Ref: **NEW RIVER C & TC – GHENT ATC RENOVATION RFB 26244**

Subj.: ADDENDUM BULLETIN NO. 6

ATC RENOVATION
NEW RIVER COMMUNITY & TECHNICAL COLLEGE
527 Odd Rd.
Ghent, WV 25843

TYPICAL HEAVY DUTY ASPHALT PAVEMENT SECTION
NOT TO SCALE

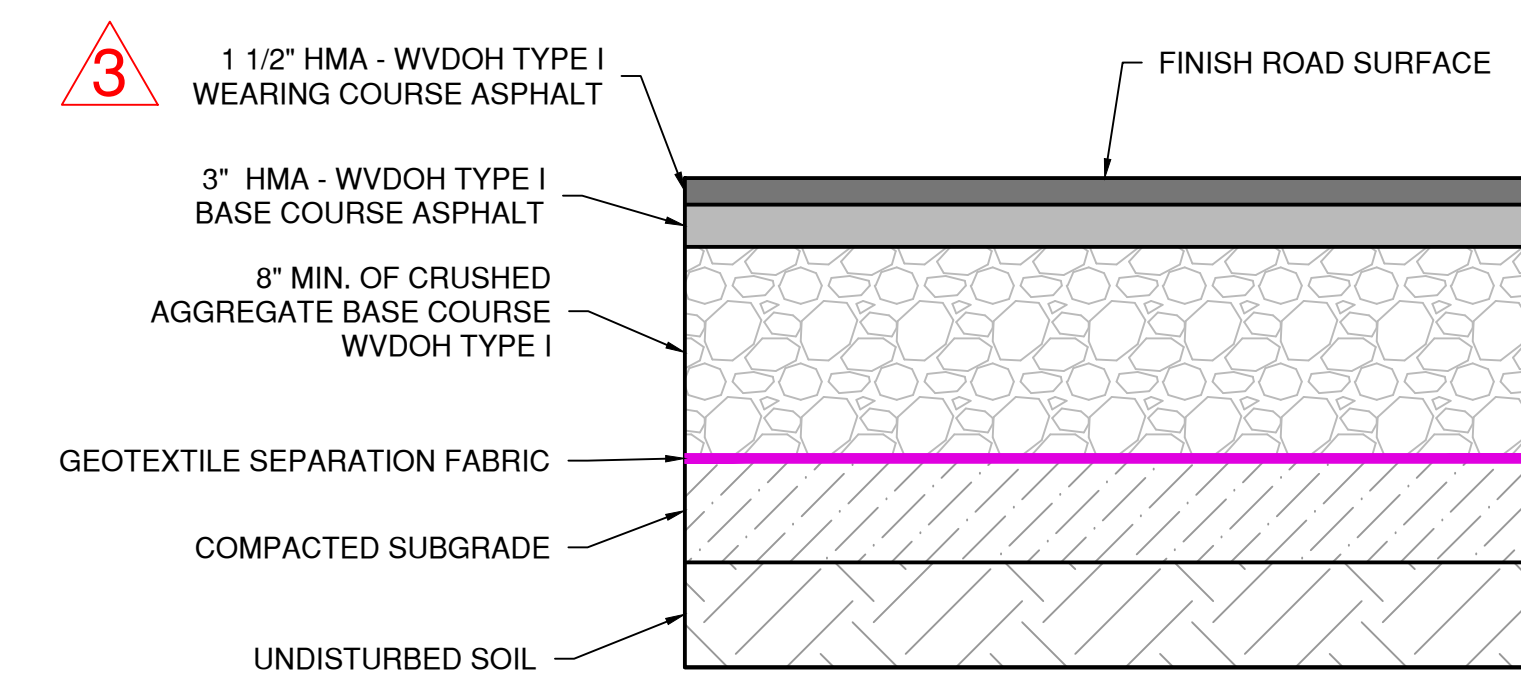
Question	Response	In Addendum
<p>Per drawing page 10/ C-5.2. Heavy-Duty Asphalt calls for 4" of Base I asphalt. Typical Asphalt calls for 3" of Base I asphalt. Per DOH handbook Base I can only be laid at a minimum of 3.25" Can 25mm Superpave be replaced for both applications? The range of 25mm is 3" to 4" minimum to maximum.</p>	<p>Yes, using the 25mm Superpave for the base on both applications will be acceptable.</p>	<p>2</p>
<p>4.What are the requirements for the Alt#2 Monument Sign? Spec section 012300-3.1 references sheets C-3.0 and A-8.1, which neither exist in the drawing set.</p>	<p>Both drawings C-3.0 and A-8.1 are in the Bid Drawings. Please clarify.</p>	<p>3</p>
<p>Could a Floor Plan and Finish Schedule be provided?</p>	<p>Drawings were provided in the Bid Drawings.</p>	<p>3</p>
<p>Where is the closest panel for EWC?</p>	<p>Refer to revised Sheet E-3.1R in Enclosures.</p>	<p>3</p>
<p>What brand of electrical panels are in the building?</p>	<p>GE. Contractor to confirm.</p>	<p>3</p>

Plan Sheet C5.2 notes 2" HMA Heavy Duty and 1 1/2" HMA Typical by others. Additionally if the HMA is by others, is the striping and concrete wheel stops by others as well. Please advise.	The "(by others)" note is incorrect. Please see attached revised detail sheet with that language removed.	6
On plan sheet C-5.2 under asphalt detail for Heavy Duty and Standard Duty. It shows Wearing I asphalt but in parenthesis it says (by others). So does Wearing I asphalt not bid in this phase of the Job?	The "(by others)" note is incorrect. Please see attached revised detail sheet with that language removed.	6
Section 083323 2.3, C., 16 There doesn't appear to be any vision lites shown on elevations Are vision lites required? If so how many?	No vision lites required in Insulated Rolling doors. Section can be removed from specification.	6
Section 083323 2.3, C., 7 Motor operators & controls are typically NEMA 1 in this type application. Is NEMA 1 acceptable rather than explosion proof?	Explosion proof is not required. NEMA 1 requirements to be met.	6

TYPICAL GRAVEL SECTION
NOT TO SCALE

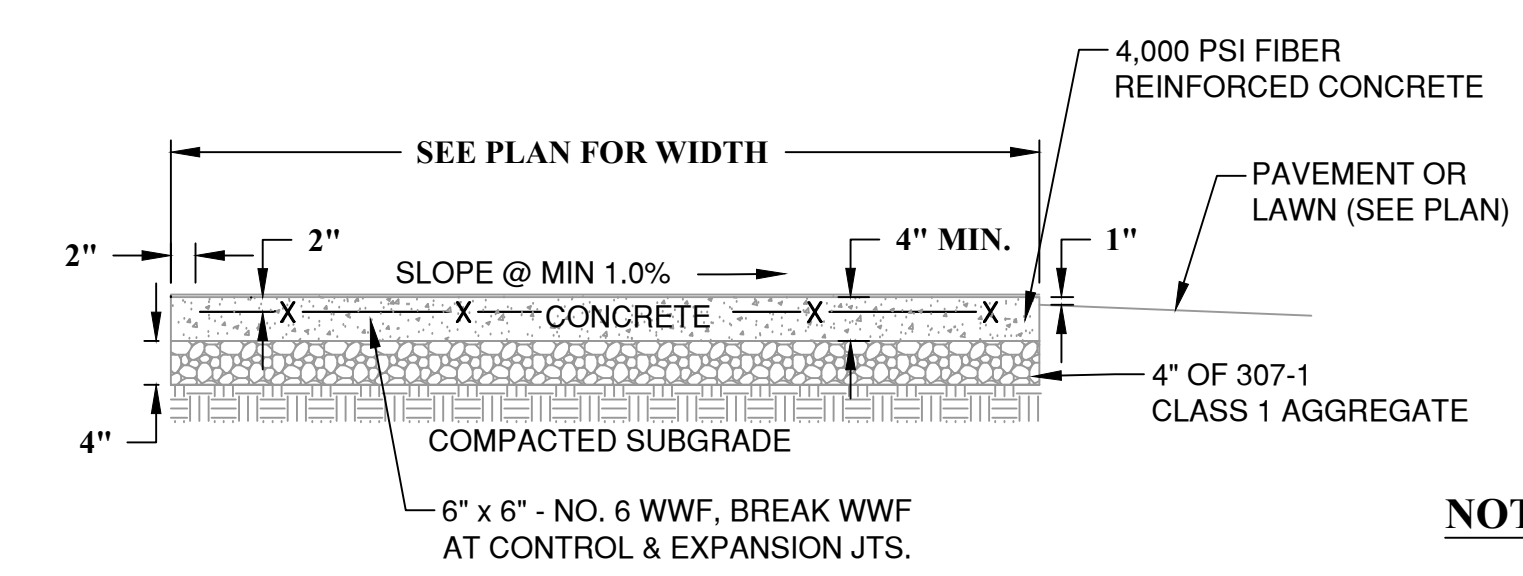
<p>The typical gravel section on Plan Sheet C5.2 indicates compacted subgrade, 4" of excavated material from existing gravel areas, and 4" of WVDOH Type 1 crushed aggregate base course. Note 1 states that existing gravel areas are to be excavated 8" and replaced per the section detail. Please confirm if the top 4" of WVDOH Type 1 is to be new stone.</p>	<p>Confirmed. 8" of material to be excavated. Lower bottom 4" can be recompacted excavated material; top 4" should be new stone.</p>	<p>3</p>
<p>Due to the petroleum market unstable pricing this year, (which includes asphalt) will there be an allowance for cost escalation of materials?</p>	<p>A price escalation/de-escalation on asphalt material will be acceptable. This cost fluctuation will be reflective of the price difference based on the month of the material purchase/installation as compared to the bid price. This change in price will directly correlate to the of the change in asphalt pricing as depicted on the WVDOH website: https://transportation.wv.gov/highways/contractadmin/Lettings/Pages/FuelandAsphaltPrices.aspx The cost escalation/de-escalation will be applied comparing the costs on the WVDOH website and then have that difference added to, or subtracted from, the contractor's bid price.</p>	<p>3</p>

E-1.1r

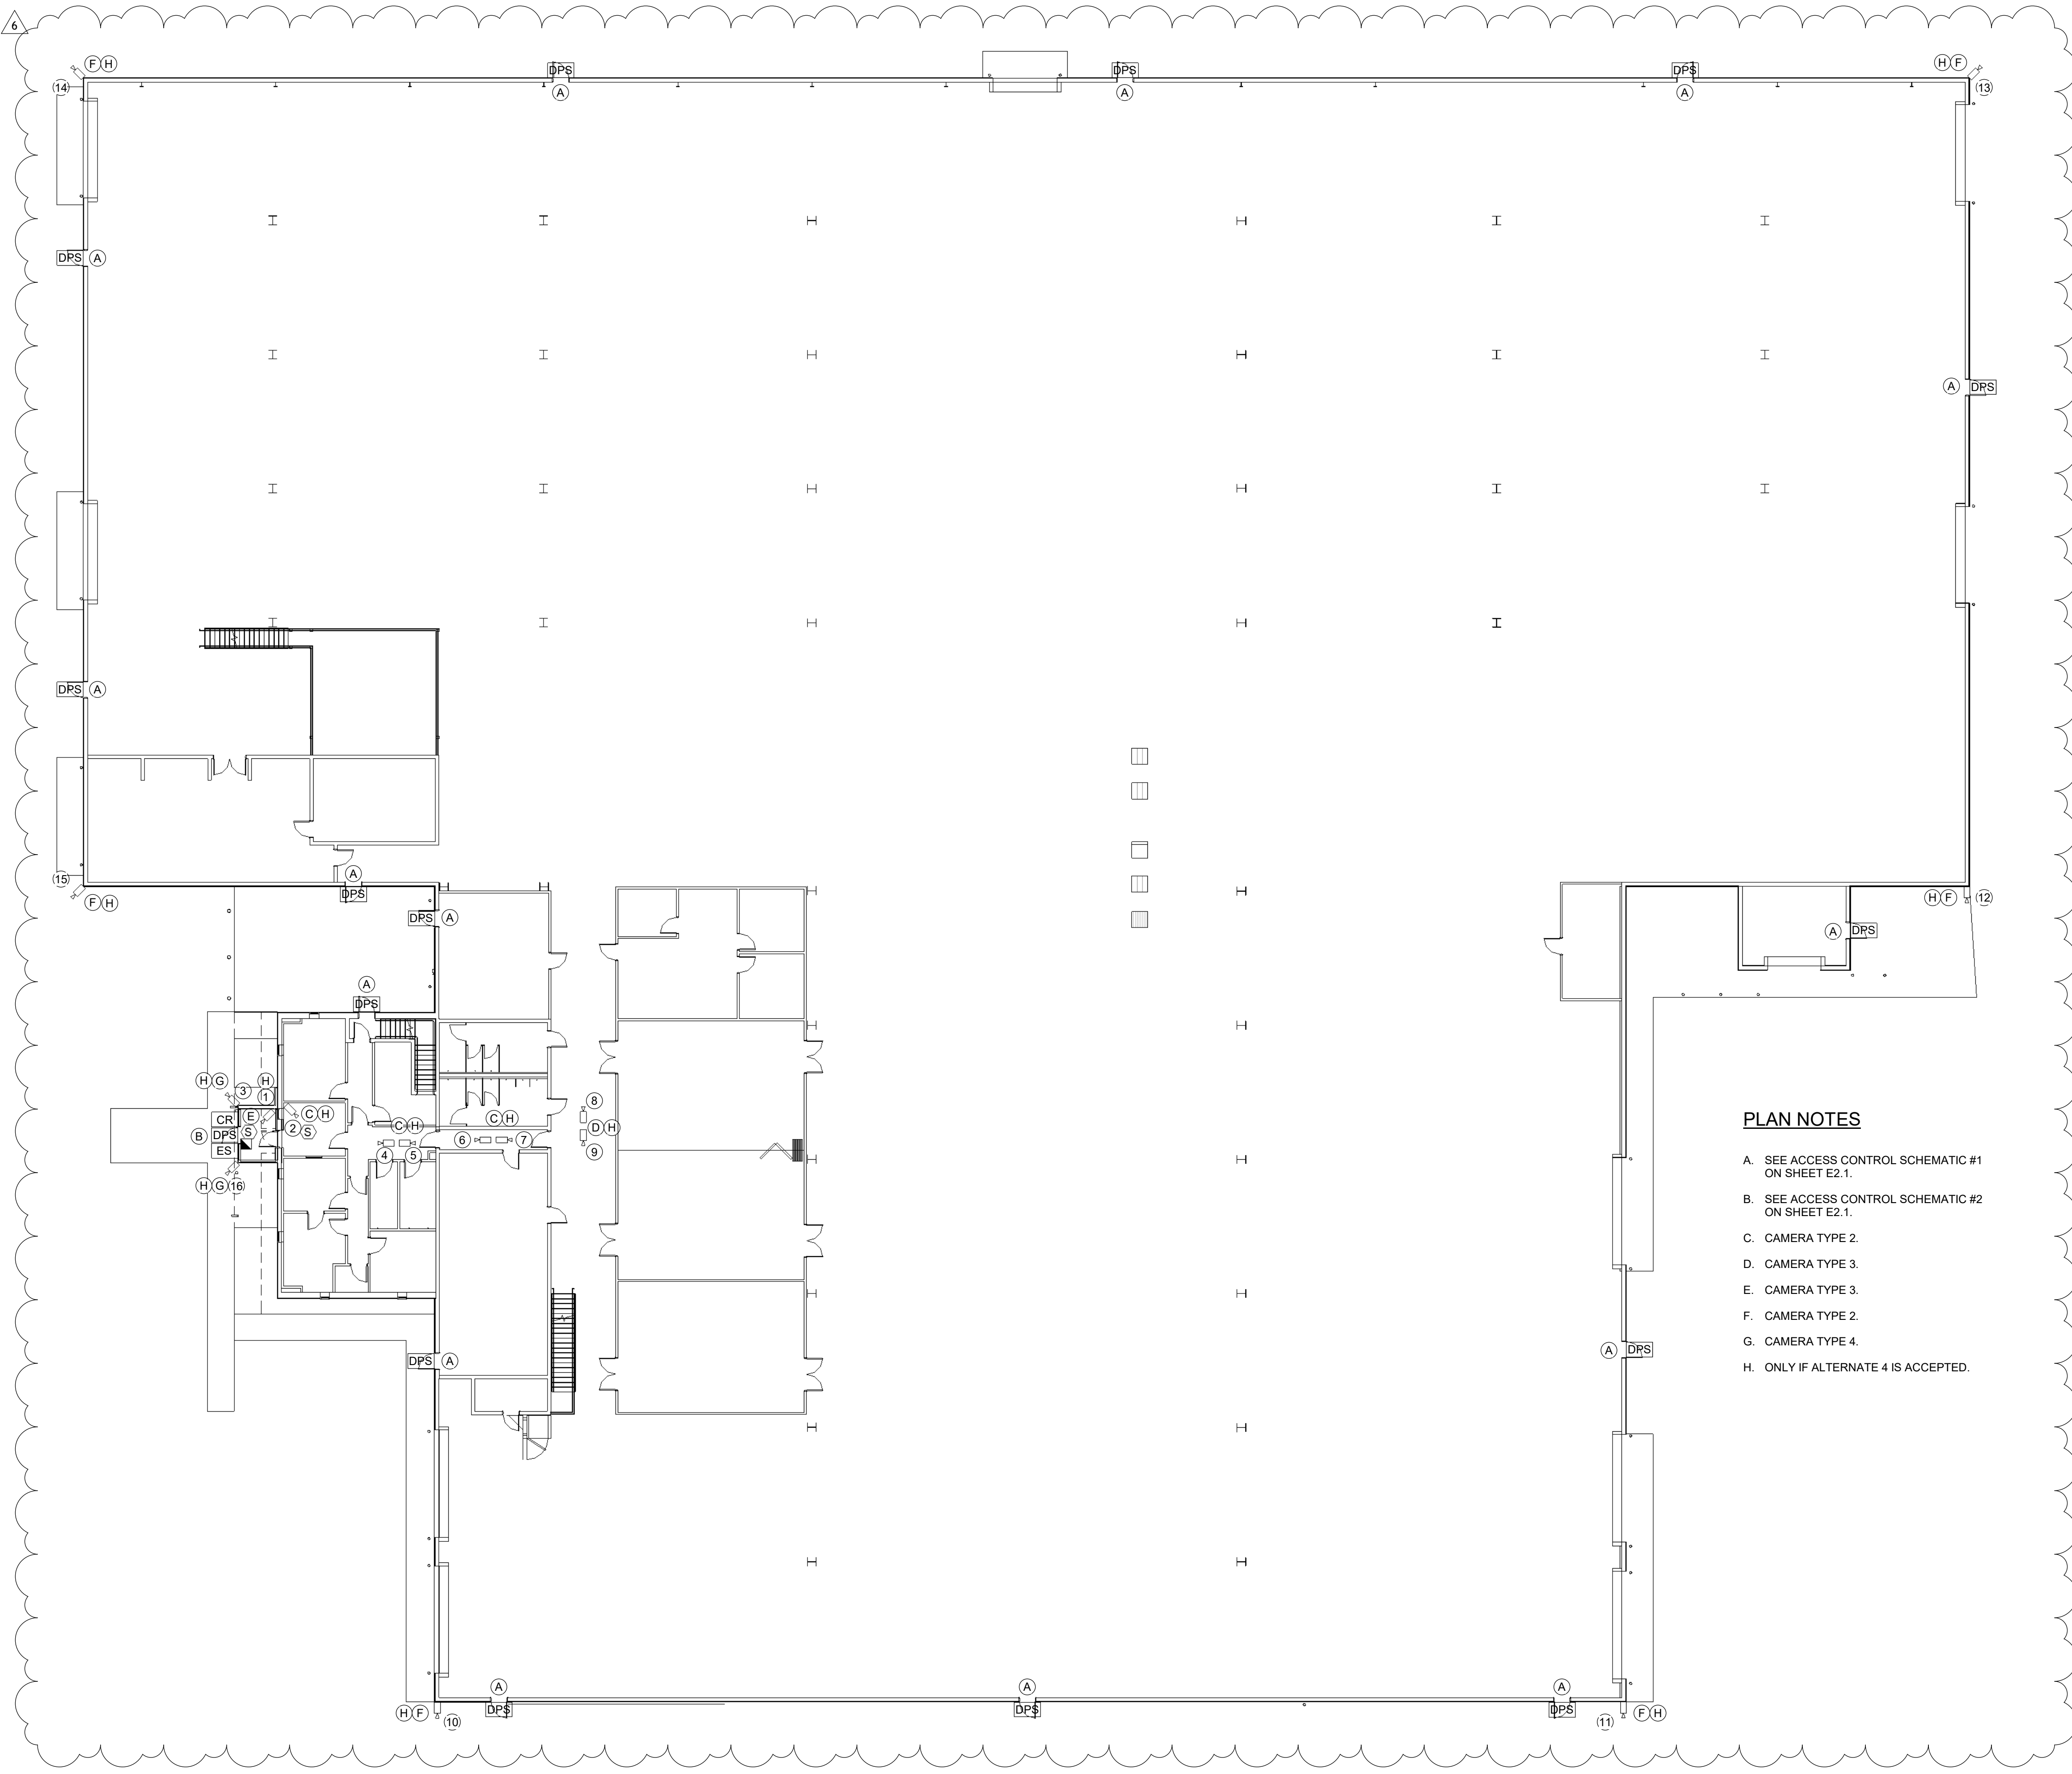
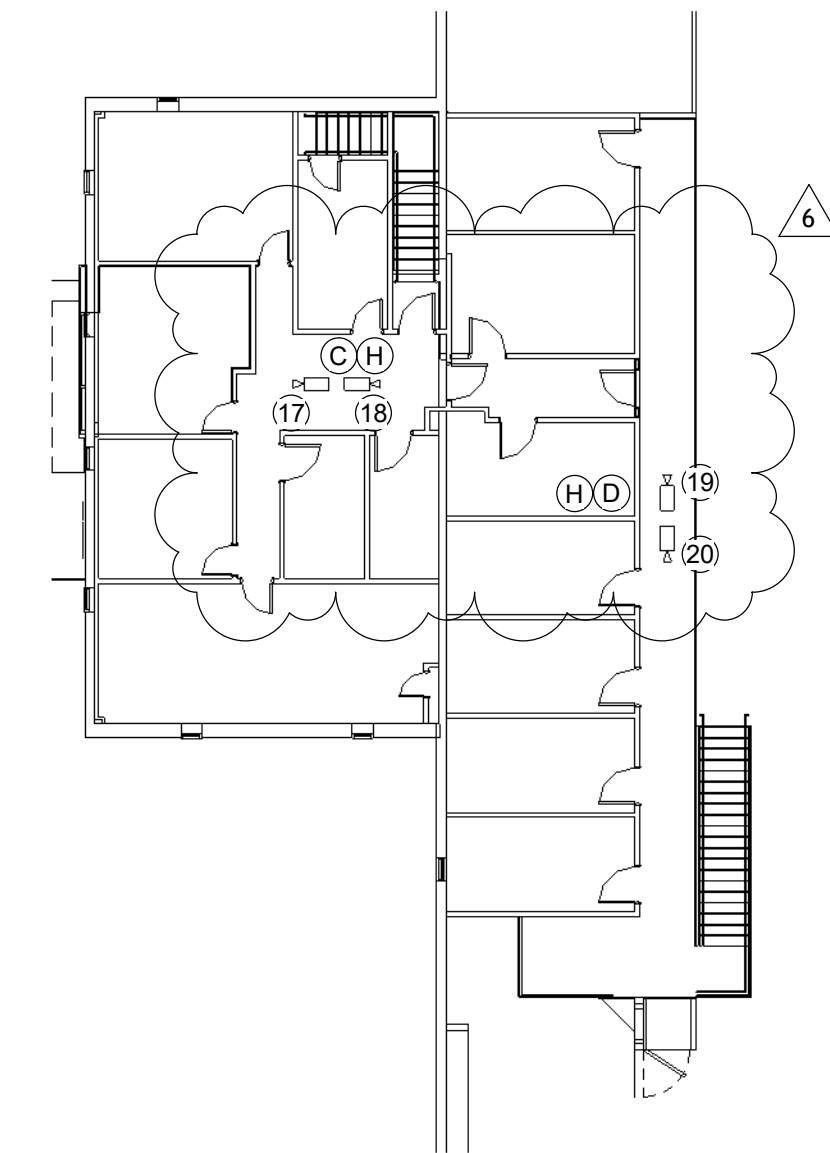
<p>Sheet S001 Note 19 calls for the steel fabricator to be AISC Certified. Can this requirement be waived?</p>	<p>It is OK to delete that requirement.</p>	<p>4</p>
<p>Reference Spec Section 282113 and Sheet E-1.1 : Could it be clarified which camera types are associated together between specs and drawing plan notes?</p>	<p>See updated E-1.1 in Enclosures.</p>	<p>4</p>
<p>The cabling lengths for the three cameras to be installed are in excess of the maximum allowable distance (300') for Cat6 cable. Is there an additional telecom room that accommodate the cameras that are too far from IT room 102?</p>	<p>Contractor to coordinate with Architect & Owner to select location appropriate for fiber requirements without interfering with current building program requirements.</p>	<p>4</p>
<p>What are the fiber requirements for the gate mentioned on Sheet E2.01?</p>	<p>This question has already been answered.</p>	<p>4</p>

Three cameras have cabling that are over length. Where is another telecom room to run the over length cables? Or how would it be handled for the over length cables?	See previous Addendum.	6
Where is the panel to get power for the access control door in the foyer on Sheet E1.1?	Use panel PP7 or see panel on second floor of office area.	6
Where is the closest panel to get power for the HVAC unit and lighting shown on Sheet E3.1?	Panel PP7.	6
Where is the closest panel to get power for each of the security gates?	Panel PP-5 and PP-8.	6
